TVA-SQN-TS-00-06

SEQUOYAH NUCLEAR PLANT (SQN) - UNITS 1 AND 2 - REVISION OF INSTRUMENTATION MEASUREMENT RANGE, BORON CONCENTRATION LIMITS, REACTOR CORE LIMITATIONS, AND SPENT FUEL POOL STORAGE REQUIREMENTS FOR TRITIUM PRODUCTION CORES (TPCs) - TECHNICAL SPECIFICATION (TS) CHANGE NO. 00-06

PROPOSED TECHNICAL SPECIFICATION (TS) CHANGE TS 00-06 AND TPBAR CONSOLIDATION ACTIVITY DESCRIPTION AND EVALUATION OF THE PROPOSED CHANGE

PROPOSED TECHNICAL SPECIFICATION (TS) CHANGE
MARKED PAGES

FIG 5.6-1 Arrangements of Fuel Storage Regions in the Sequoyah Spent Fuel Storage Pool

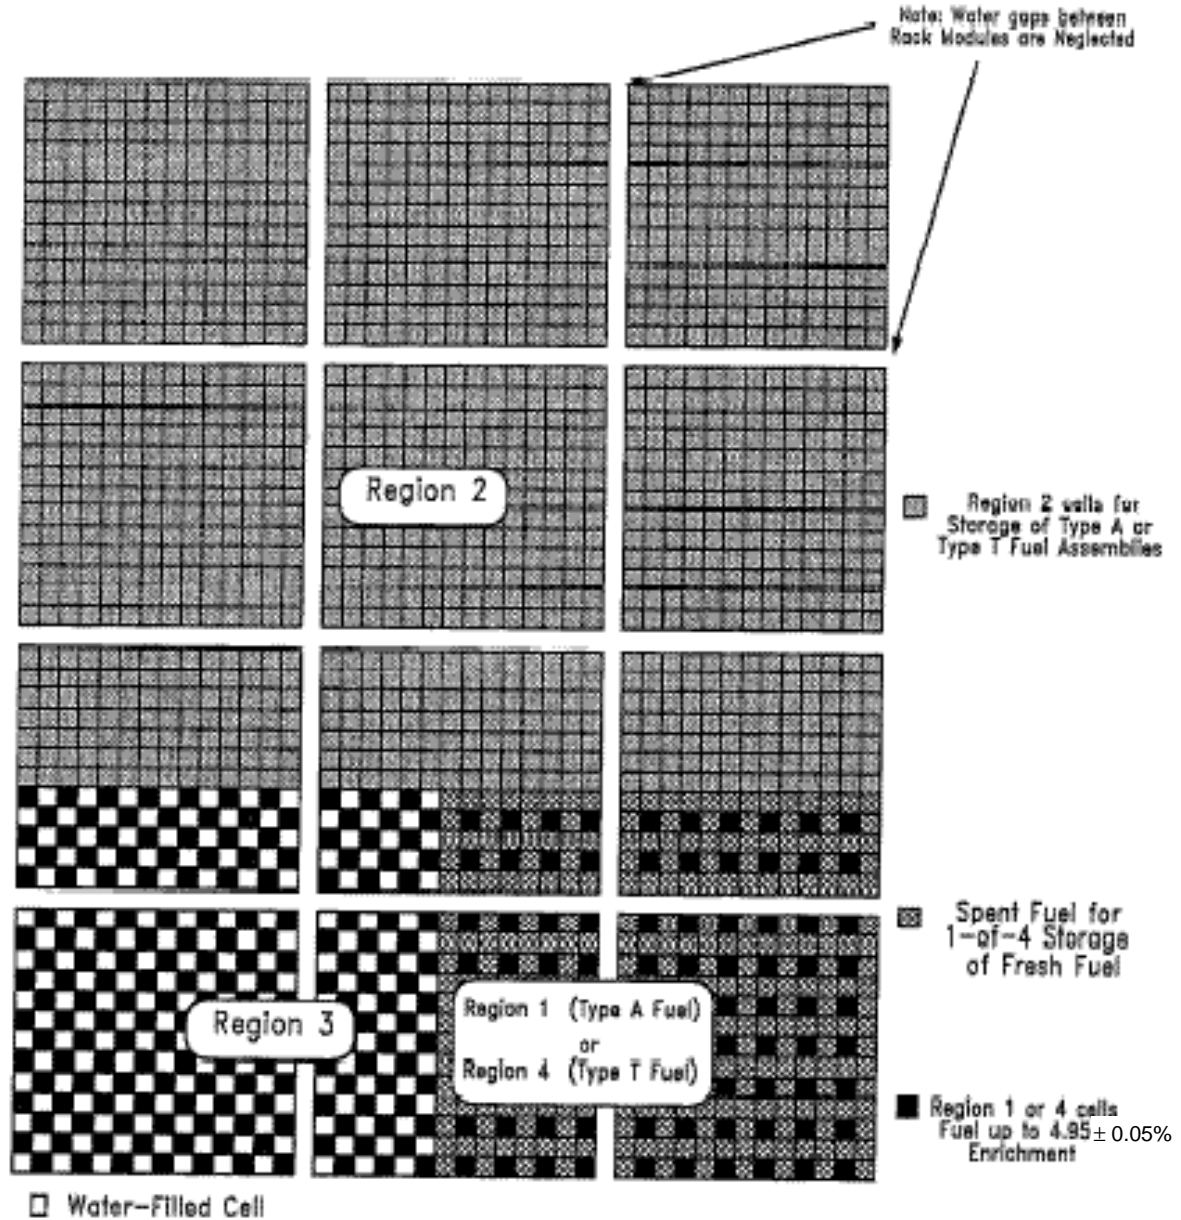
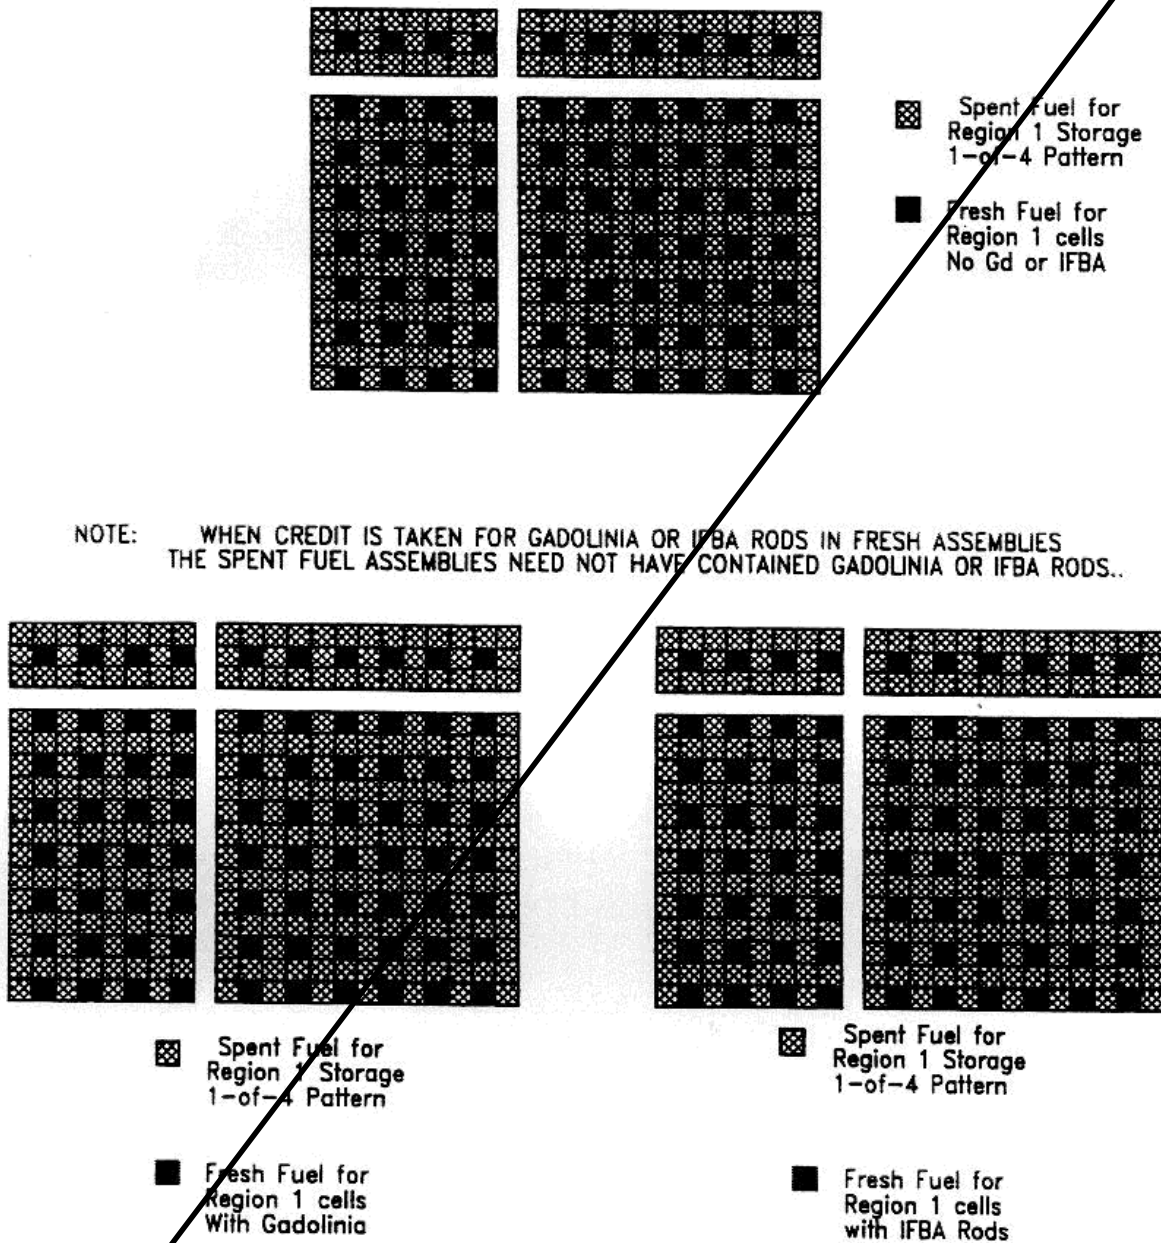
Current Section 5.6.1.1 is being revised to accommodate new provisions that address the storage of spent fuel that contained TPBARs. Information has been included at the beginning of this section to define Type A fuel (spent fuel that has not contained TPBARs), Type T fuel (spent fuel that has contained TPBARs), fresh fuel, and cooling time. Spent fuel pool Region 1 is designated to contain fresh fuel and spent fuel Type A. Region 2 is designed to contain spent fuel Type A or Type T. Region 3 is designated to contain fresh fuel only. Region 4 is designated to contain fresh fuel and spent fuel Type T. As part of the revisions to Section 5.6.1.1, clarifying information regarding storage cells partially filled with non-fissile material has been included for all regions. This revision also deletes current Section

The figures and tables associated with Section 5.6.1.1 have been revised accordingly to properly represent the acceptable spent fuel storage patterns for each fuel type with appropriate enrichment, burnup, and cooling time requirements for storage in respective regions of the spent fuel pit. This change has revised the labels for the existing figures and tables to clarify their use for Type A spent fuel and has included other changes to reflect the new Type T spent fuel. New figures and tables for Type T spent fuel have been added with appropriate labels and information for controlling storage requirements for this fuel.

Note: The edges of the sketch above are not necessarily the edges of the pool. The Regions may appear anywhere in the pool and in any orientation, subject to the restrictions in Design Features 5.6.1.1.a.

Fig. 5.6-1a Acceptable Storage Patterns for Checkerboard Storage of Fresh and Spent Fuel Assemblies in Region 1 or Region 4 - Example

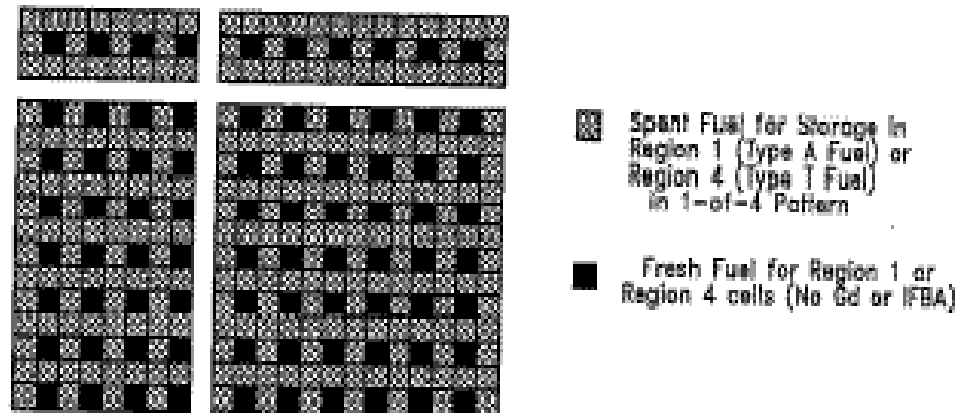
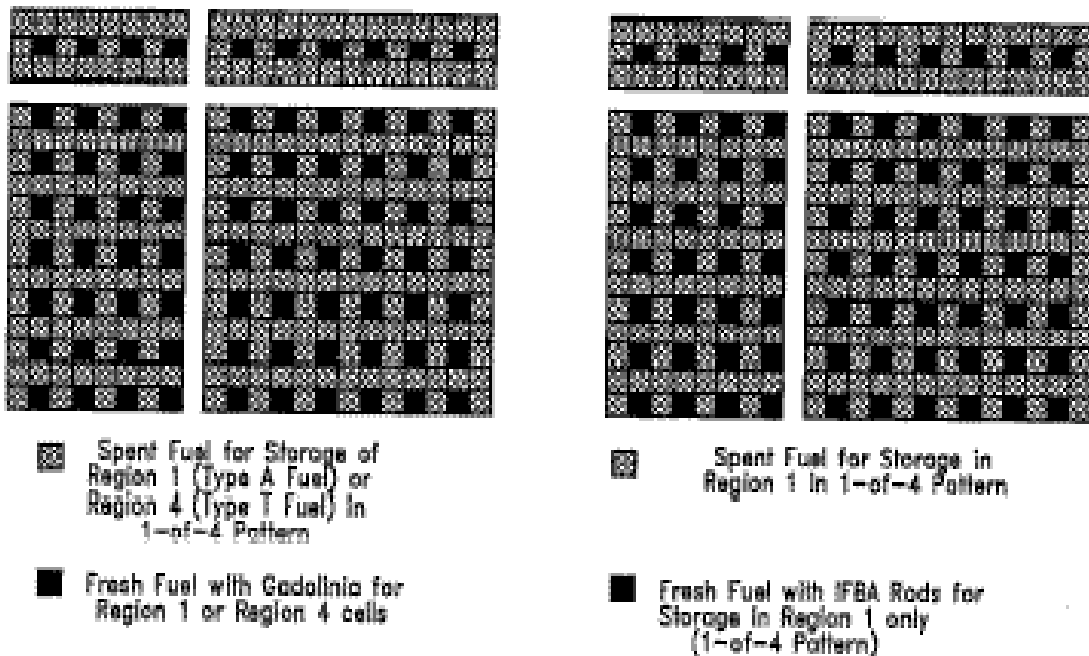
NOTE: WHEN CREDIT IS TAKEN FOR GADOLINIA RODS IN FRESH ASSEMBLIES THE SPENT FUEL ASSEMBLIES NEED NOT HAVE CONTAINED GADOLINIA RODS.

Fig. 5.6-2 3-Dimensional Plot of Minimum Fuel Burnups in Region 1 for Enrichments and/or Cooling Times

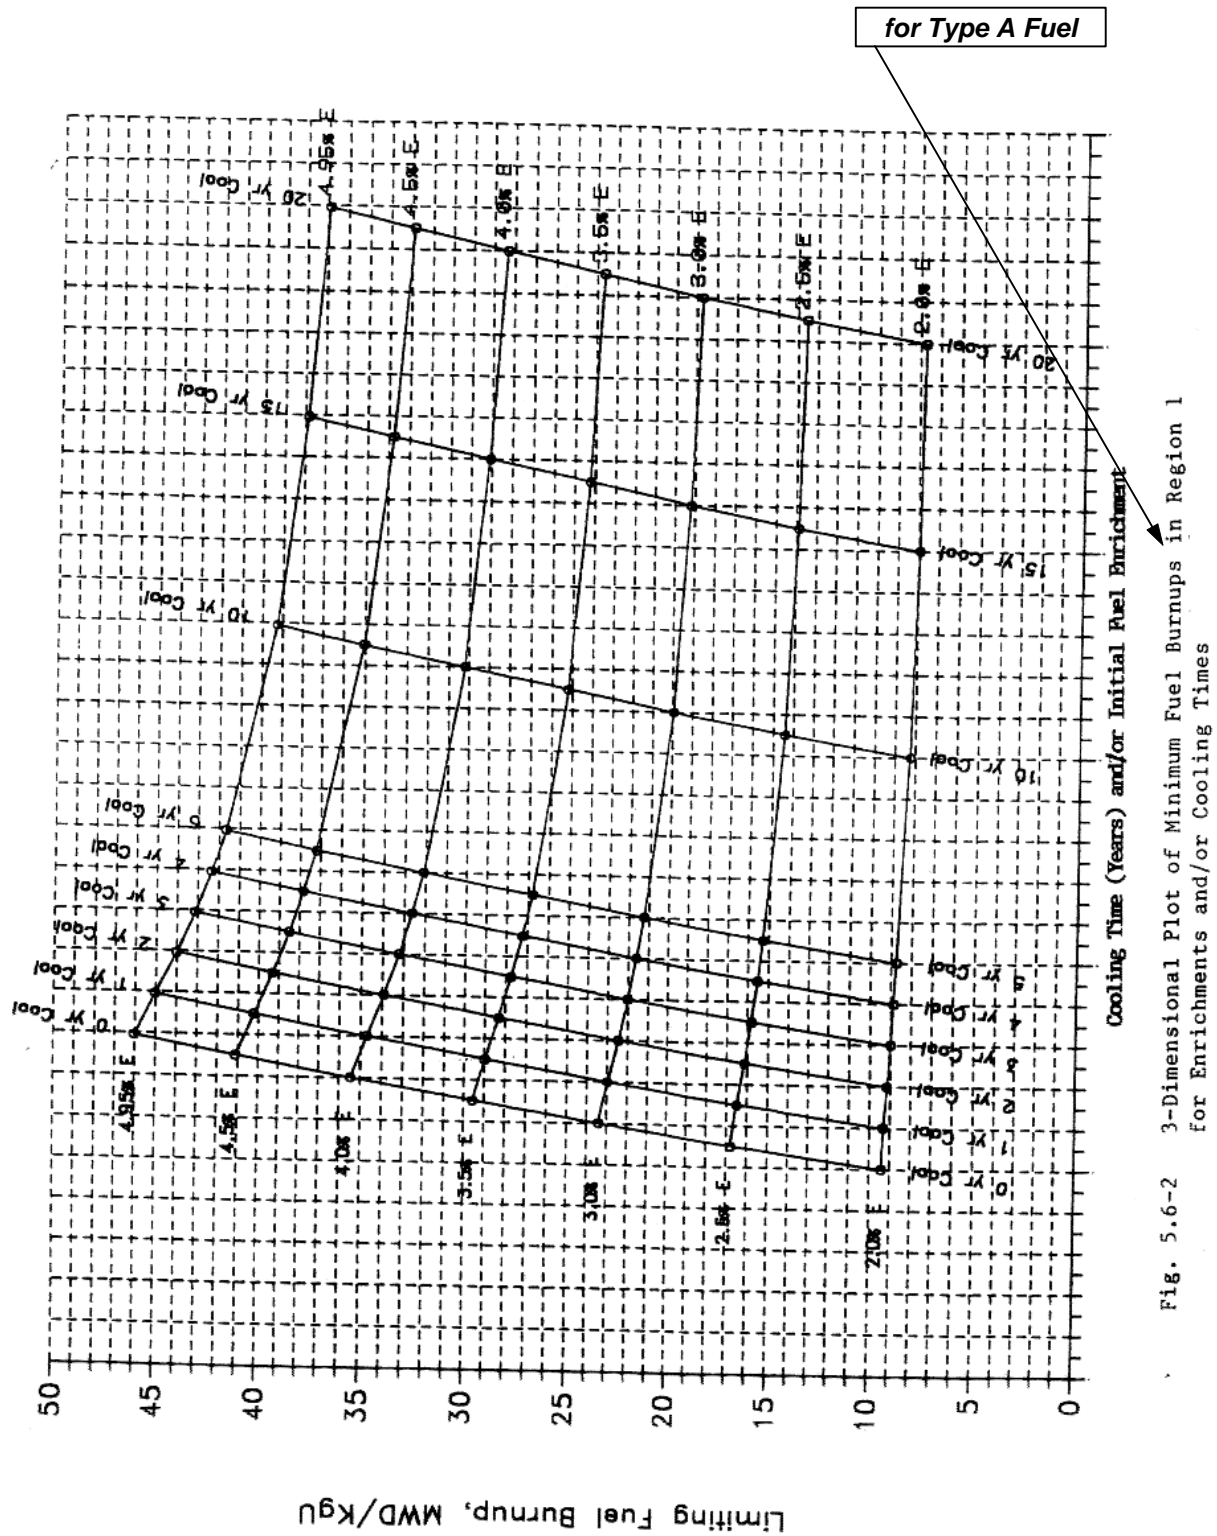
For Type A Fuel

Figure 5.6-4 **5.6-7**
New Fuel Pit Storage Rack Loading Pattern

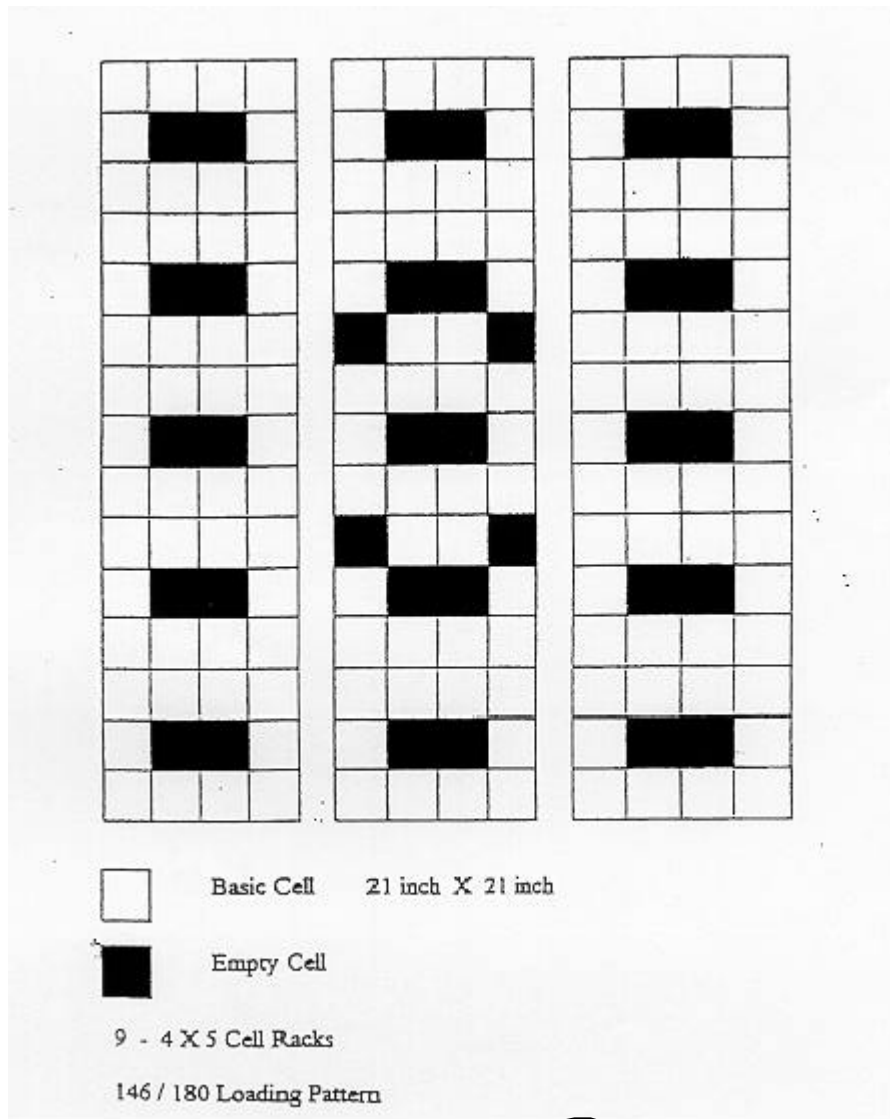
[Add Inserts 14, 15, and 16]

Fig. 5.6-4 Limiting Burnup Requirements in Region 2 for
Face Adjacent Storage of Type T Spent Fuel
Assemblies

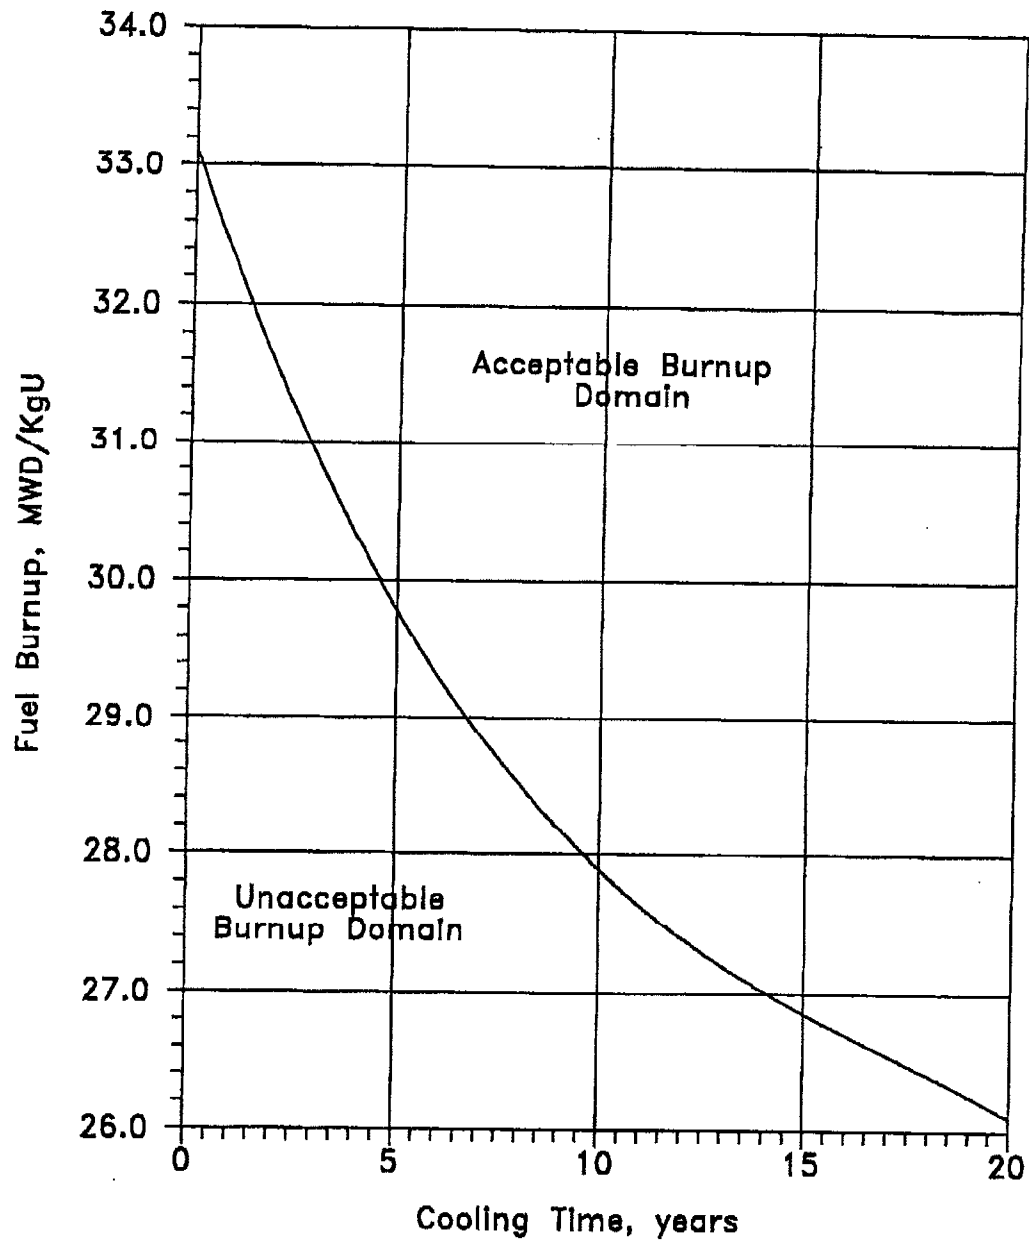
Insert 14

Fig. 5.6-5 Limiting Burnup Requirements in Region 4, Checkerboard Array of 1 Fresh and 3 Type T Spent Fuel Assemblies

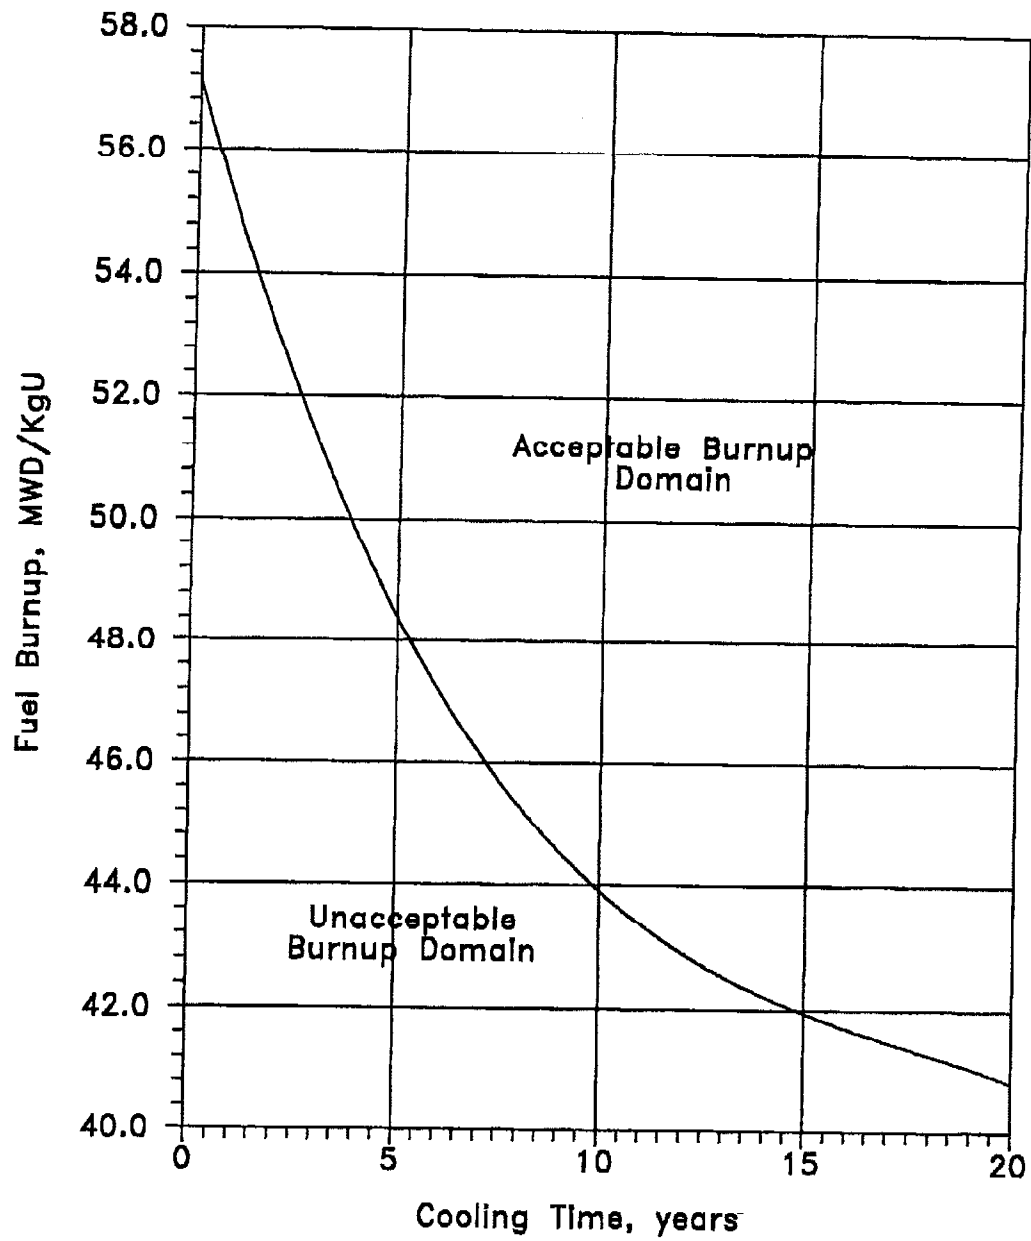
Insert 15
